Access Compliance Report Public Rights-of-Way (Curb Ramps)

Main Street: POONA_DR Cross Street: CERRITOS_AVE Location: NE

ADA ID: RPAT220203133545 Ramp Type: Type 4 - Parallel Initial Pass/Fail: Pass Overall Compliance: No Severity Score: 0

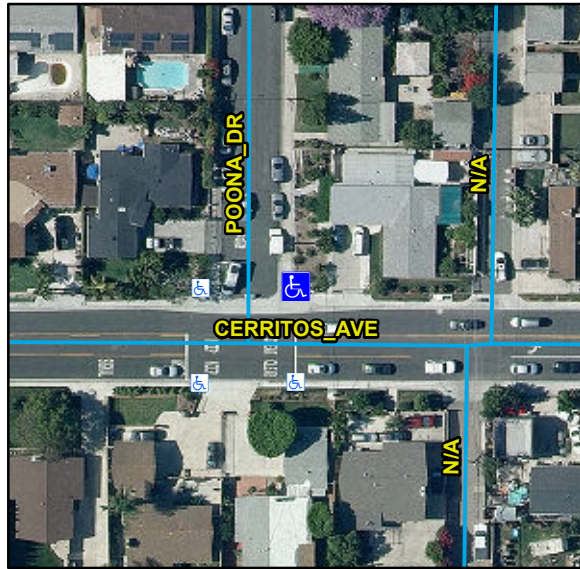
Compliance	Description	Data	Compliance	Description	Data
N/A	Ramp Length LT (in)	97	N/A	Ramp Length RT (in)	98
Yes	Ramp Width LT (in)	56	Yes	Ramp Width RT (in)	55
Yes	Ramp Run Slope LT (%)	5.3	Yes	Ramp Run Slope RT (%)	5.8
Yes	Ramp Cross Slope LT (%)	1.5	Yes	Ramp Cross Slope RT (%)	0.1
N/A	Landing Present	Yes	Yes	DWS Provided	Yes
N/A	Landing Length (in)	54	Yes	DWS Contrast	Yes
Yes	Landing Width (in)	48	Yes	DWS Length (in)	36
No	Landing Run Slope (%)	2.4	Yes	DWS Full Width	Yes
Yes	Landing Cross Slope (%)	0.1		DWS Offset Type	Single
N/A	Landing Movement Obstructed?	No	Yes	DWS Offset Left (in)	0
	Landing Movement Type	Curb	Yes	DWS Offset Right (in)	N/A
N/A	Landing Shared	No			
N/A	Clear Space	Yes			
N/A	Clear Space To Crosswalk (in)	48			
N/A	Marked Crosswalk 1	No	N/A	Marked Crosswalk 2	No
	Crossing 1 Direction	W		Crossing 2 Direction	S
N/A	Marked Crosswalk 1 Width (in)	N/A		Marked Crosswalk 2 Width (in)	N/A
N/A	Ramp Inside Crosswalk 1	N/A	N/A	Ramp Inside Crosswalk 2	N/A

Possible Solutions:

Remove & Replace Landing.
